Marcovich Mining Resource AR#1 Response

Marcovich Resource 112c Construction Materials Reclamation Permit Application

Adequacy comments and responses:

INDEX MAP

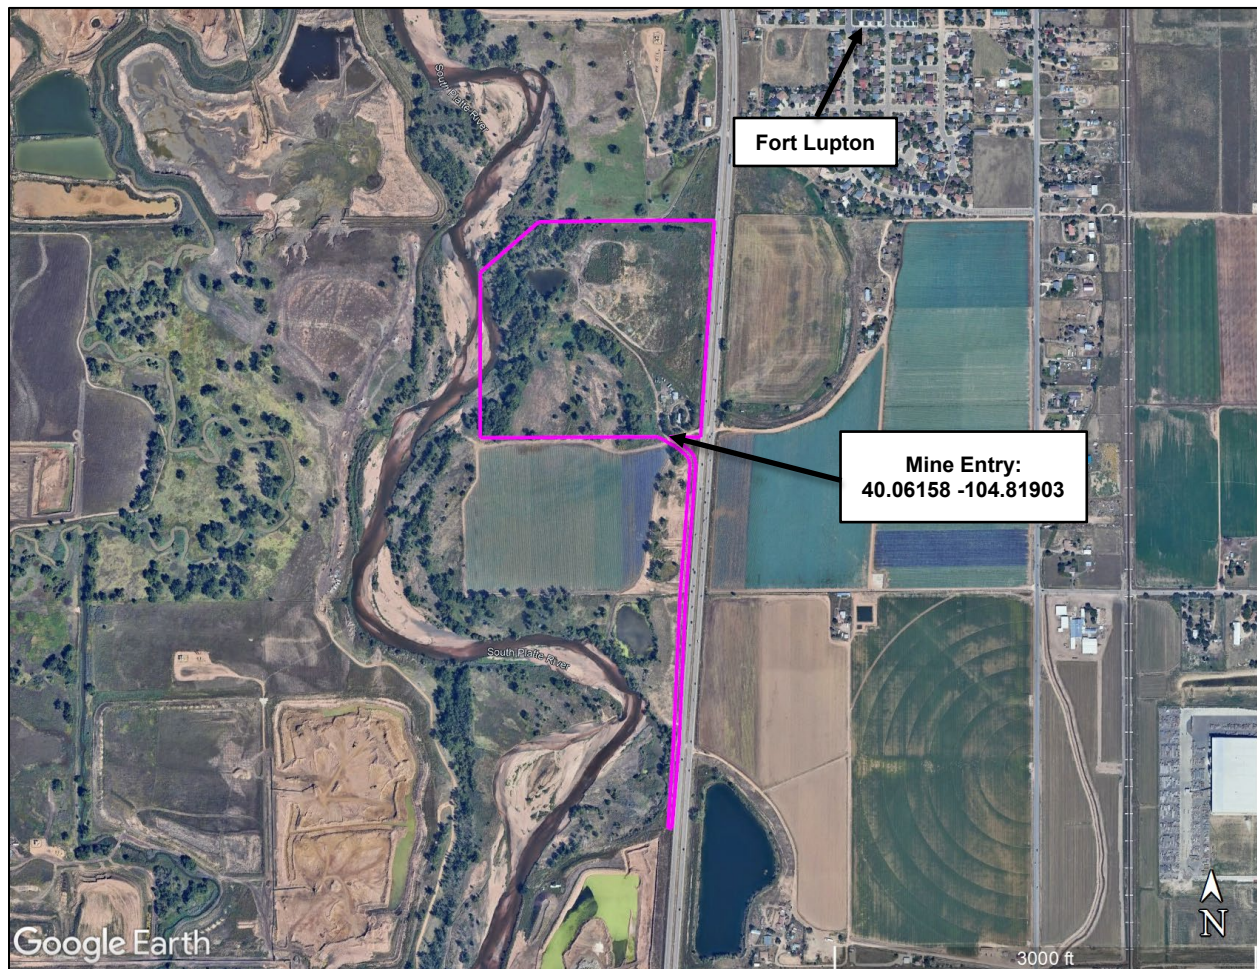
- Adequate as submitted.

Hunt Brothers Properties, Inc. easement has been added to Exhibit B Index Map.

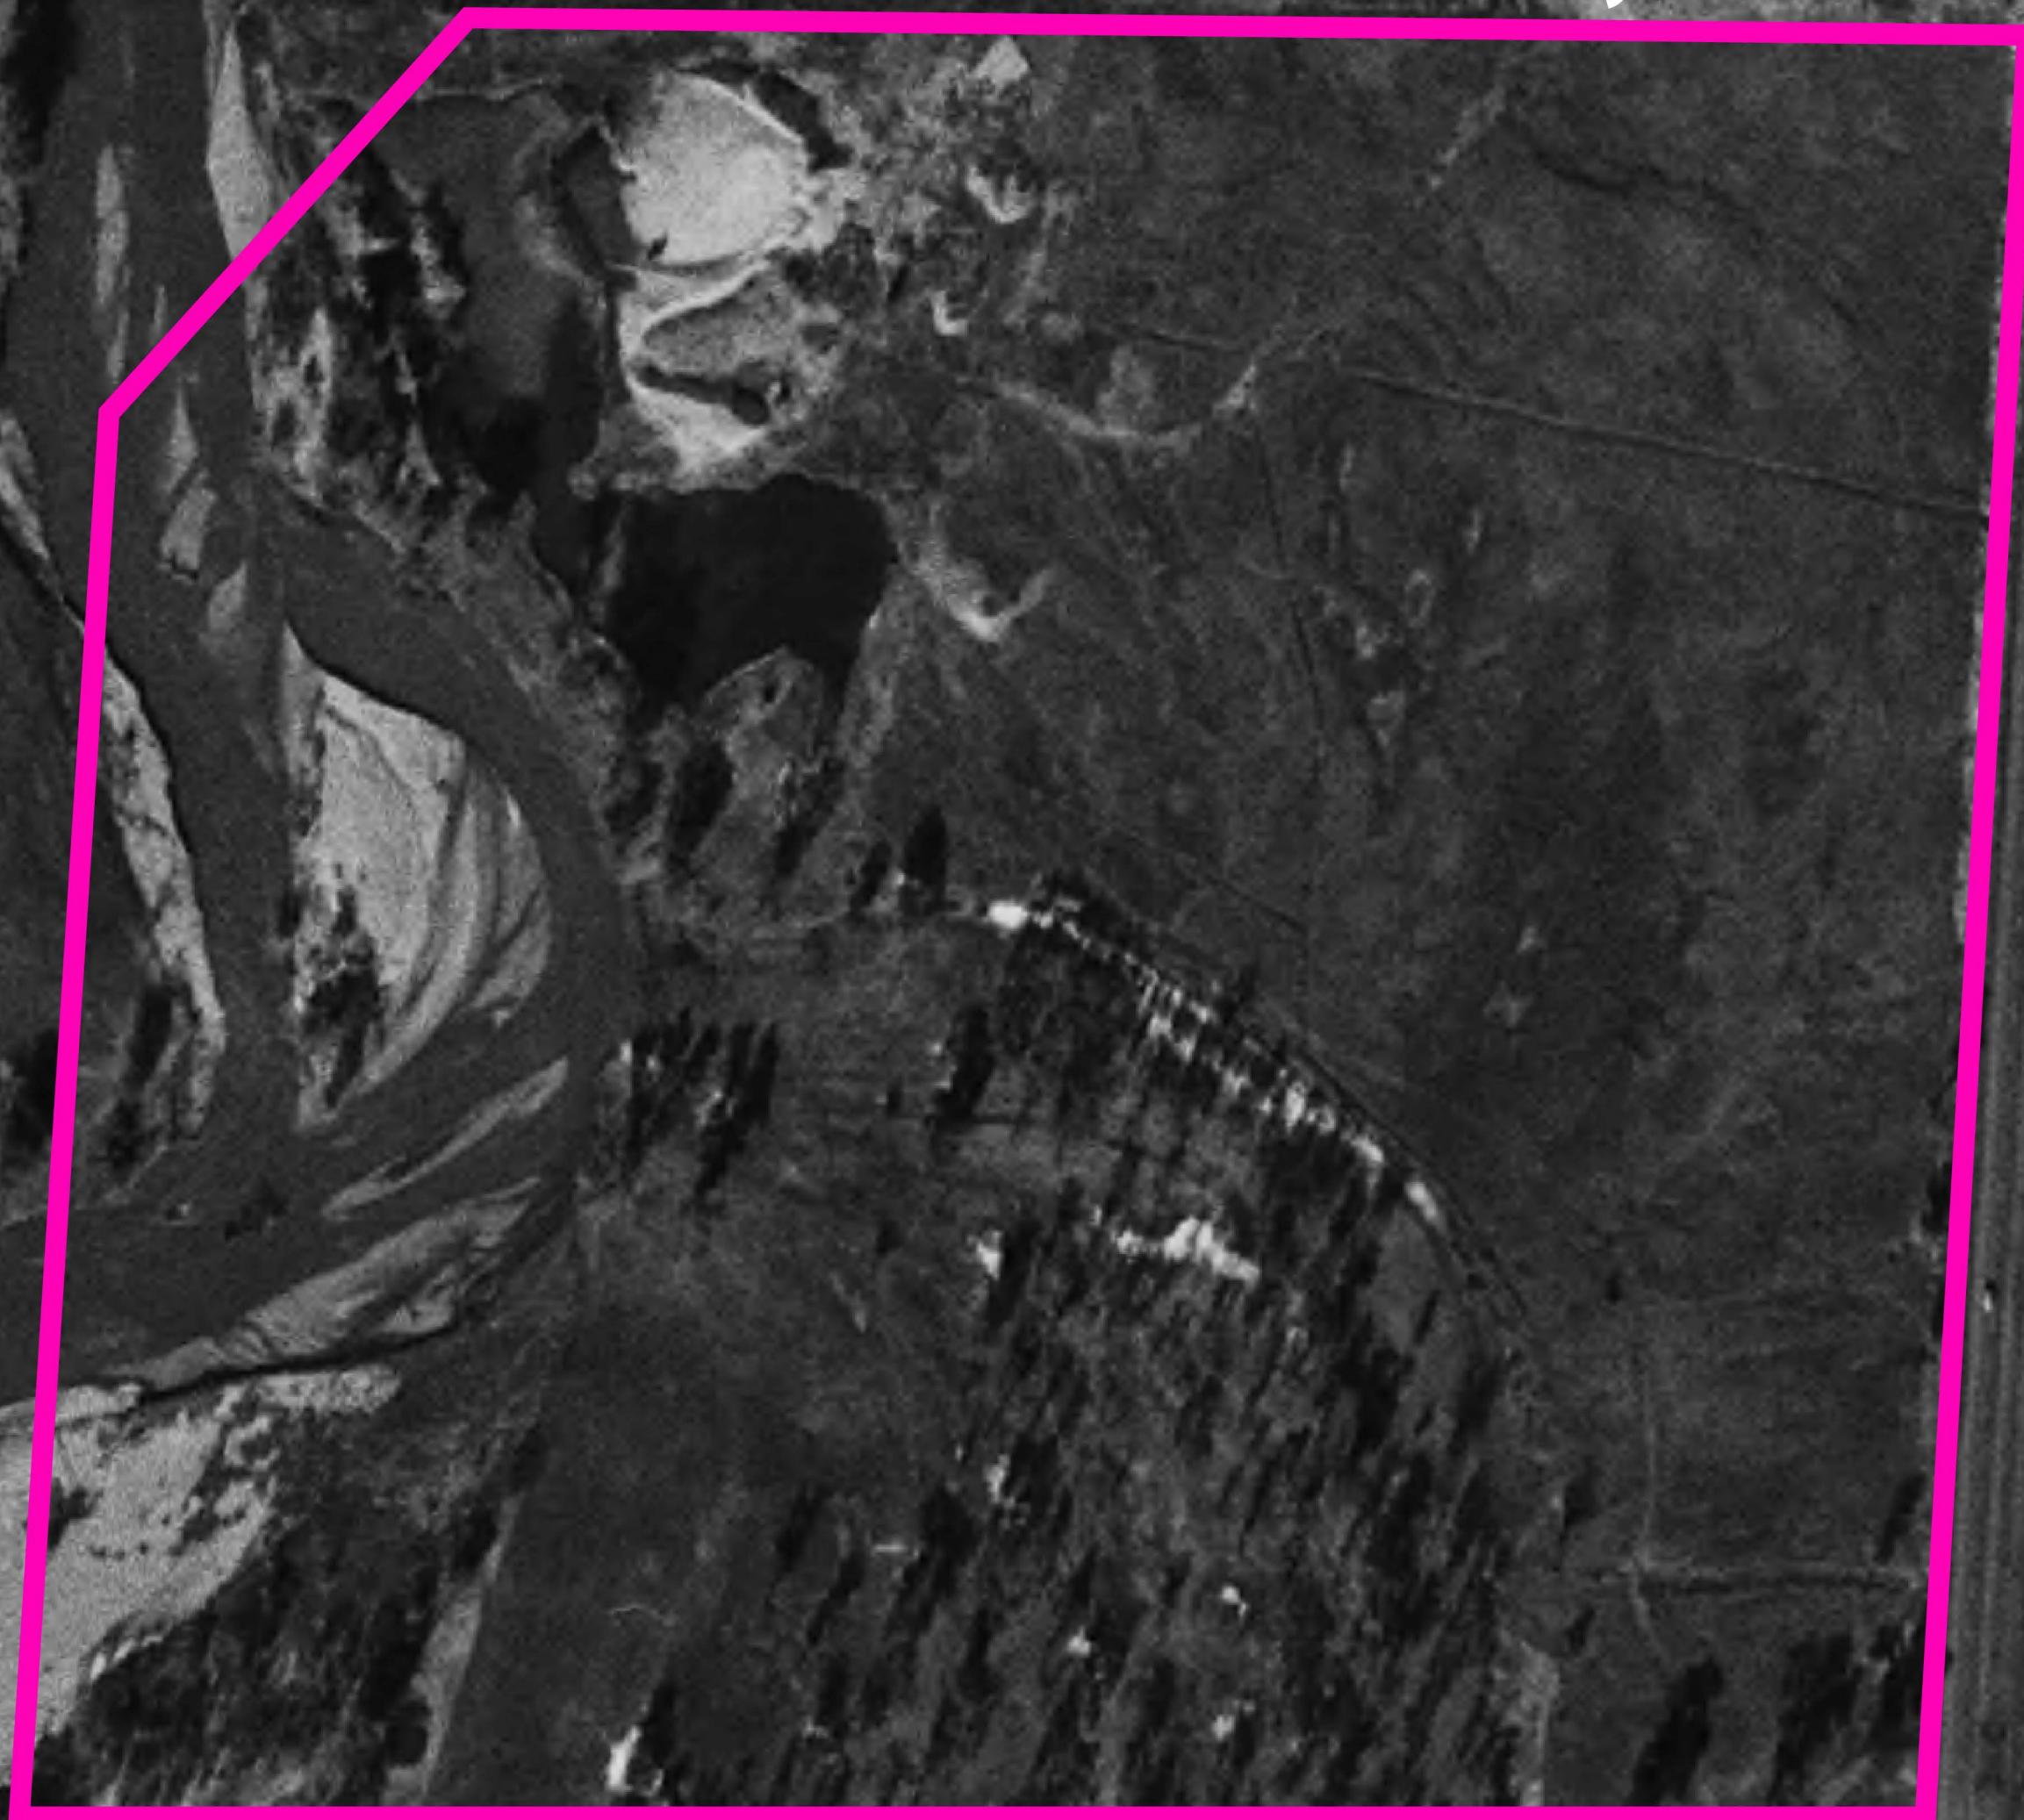
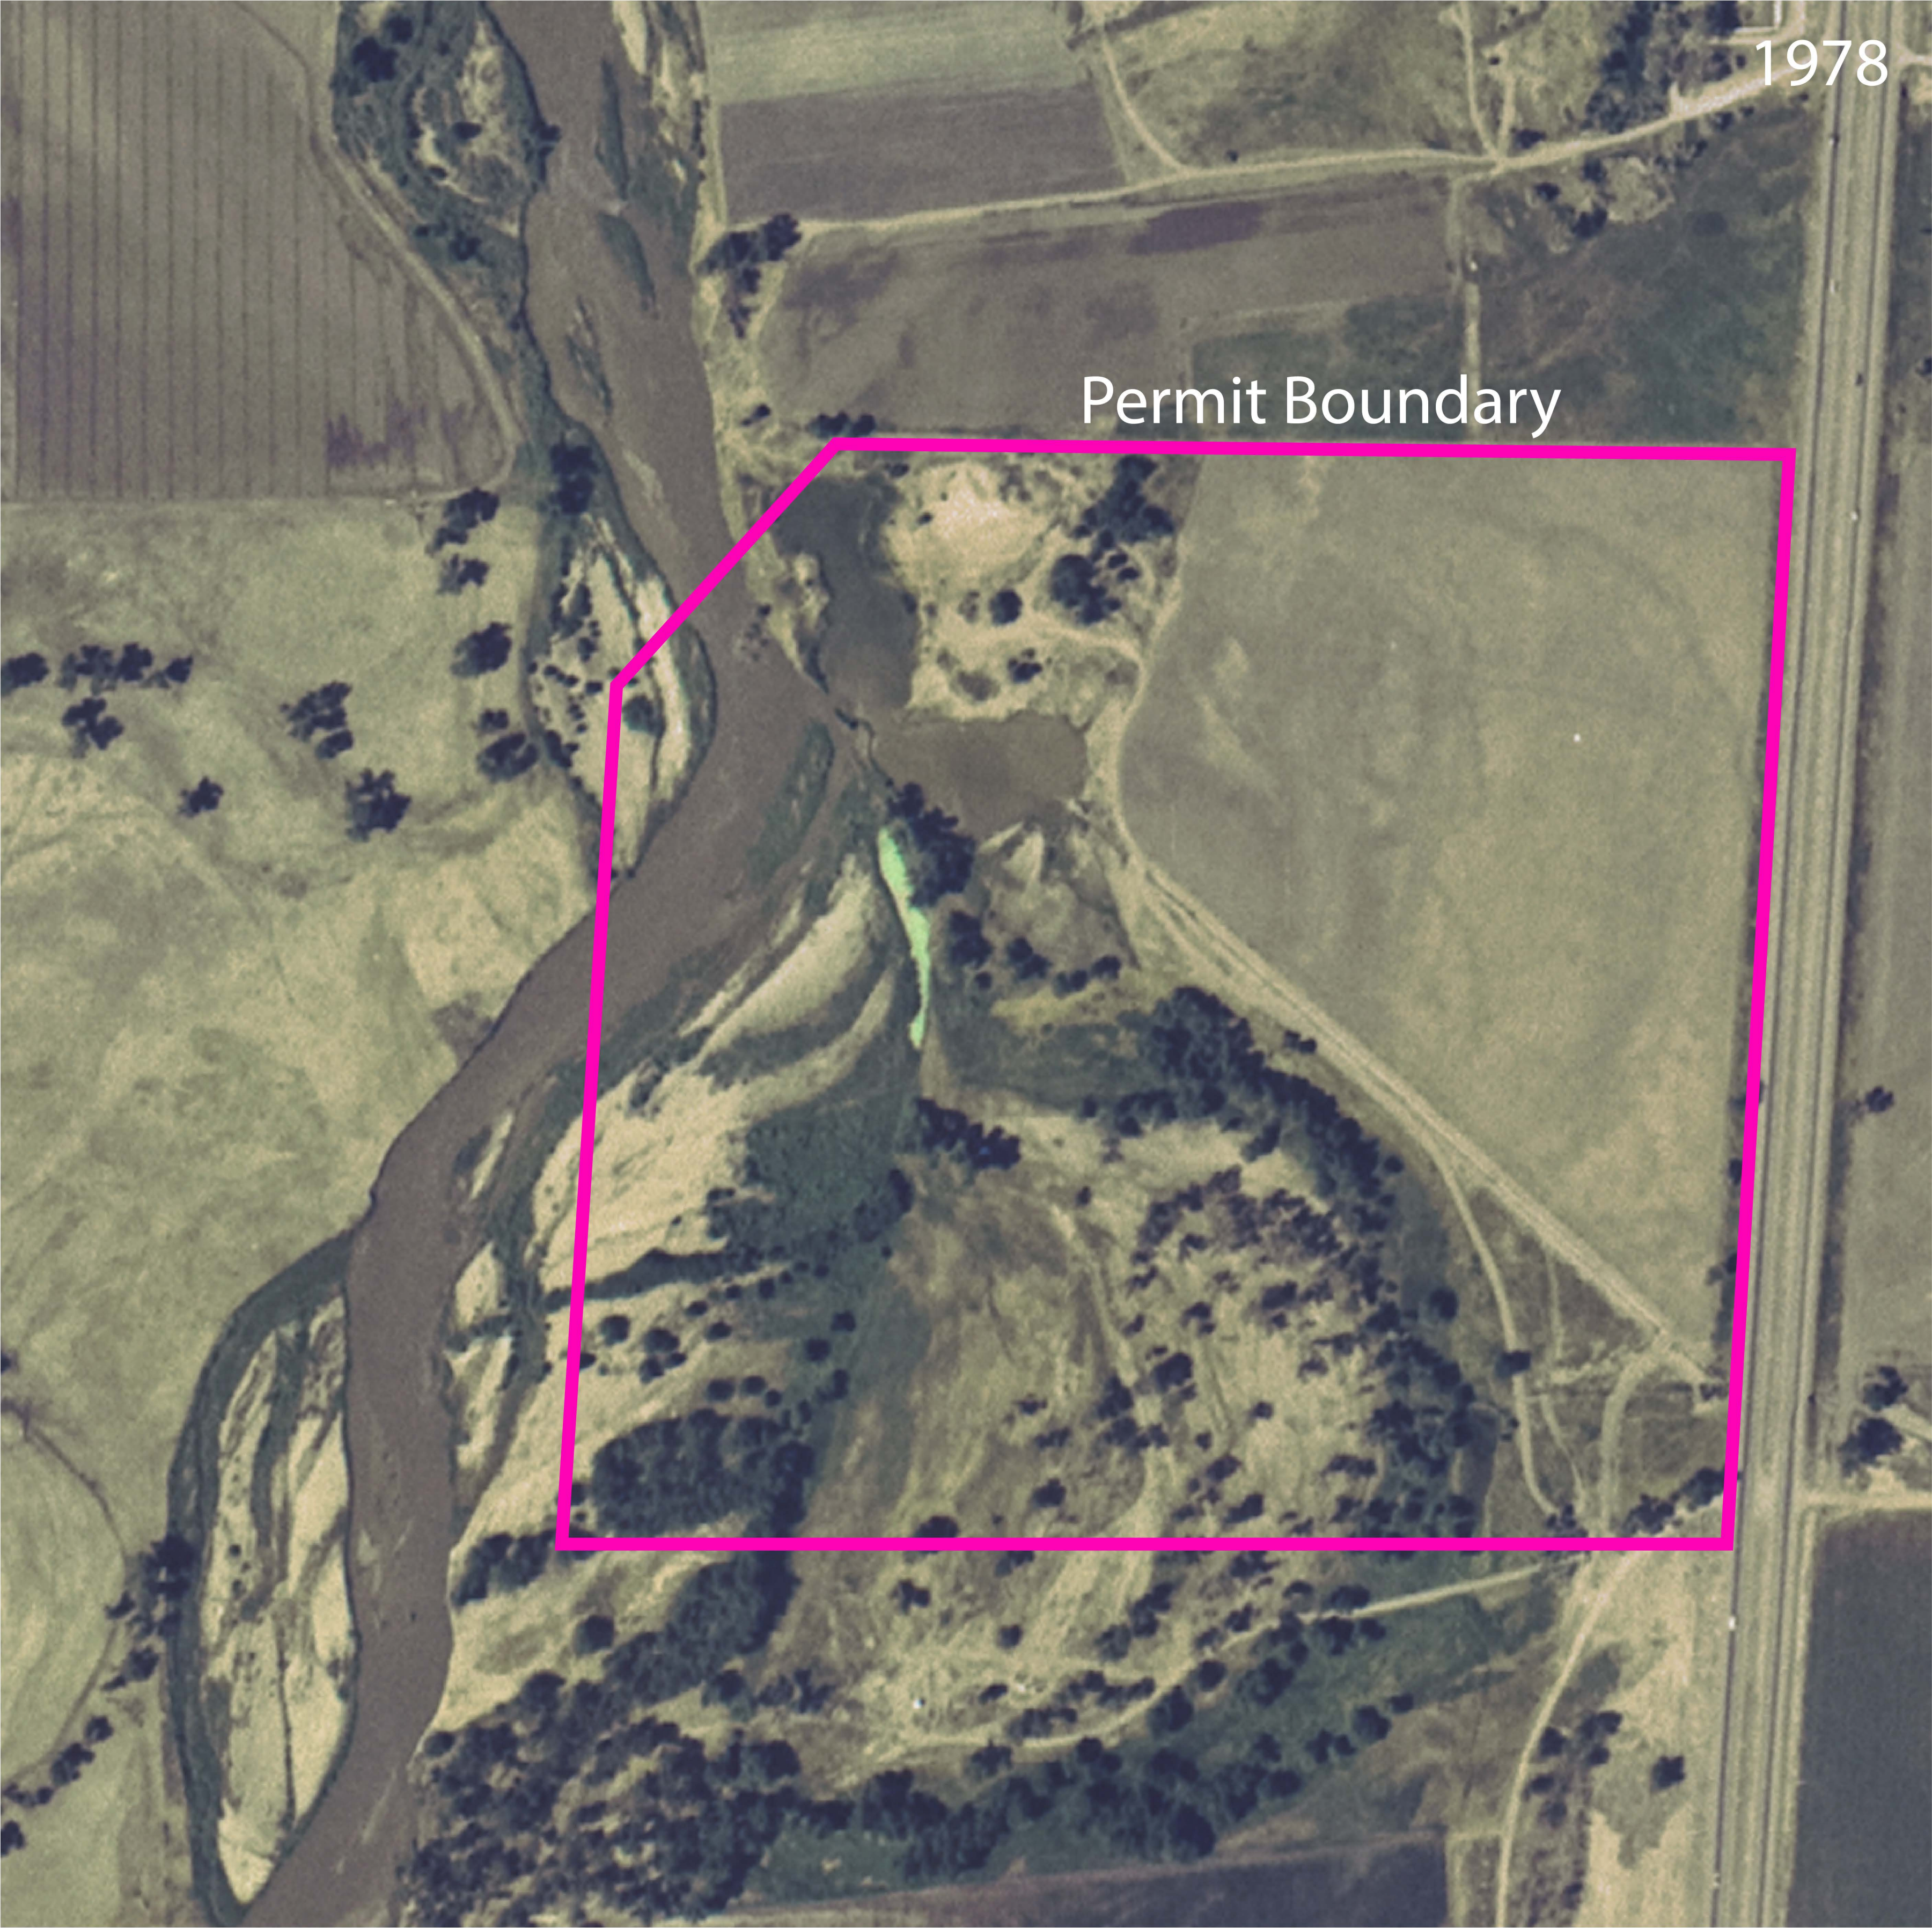
- During the pre-operation inspection, the Operator discussed pumping water from the pit into a pond on in the northwestern portion of the permit area. According to the July 19, 2024 comment letter from Division of Water Resources (DWR), irrigation tailwater may be illegally being collected and used for livestock and the applicant may need to have a long-term SWSP or permanent augmentation plan even after reclamation if the reservoir will collect stormwater runoff. Per Rule 3.1.6, please explain this comment and state how the operation will be in compliance with the applicable Colorado water laws and regulations governing injury to existing water rights.

Please see the attached series of photos depicting the history of the pond on the site. The pond is the remanent of a gravel pit that operated from 1960's until being captured by the river in the late 1970's. Central Colorado Water Conservancy District (CCWCD) installed augmentation wells east of Highway 85 that discharged into a ditch, flowed underneath the highway and into the pond in question. In 2009, CCWCD was ordered to cease and desist from pumping those wells. The ditch has remained abandoned since those orders. Billy Mihelich, PE, the district engineer authorized the ditch be removed by the mining. The mine's intent is to utilize the pond as a discharge point for dewatering activities to prevent potential for erosion at the discharge point. Historic aerial photos have been attached to demonstrate that the pond was part of a historic gravel pit.
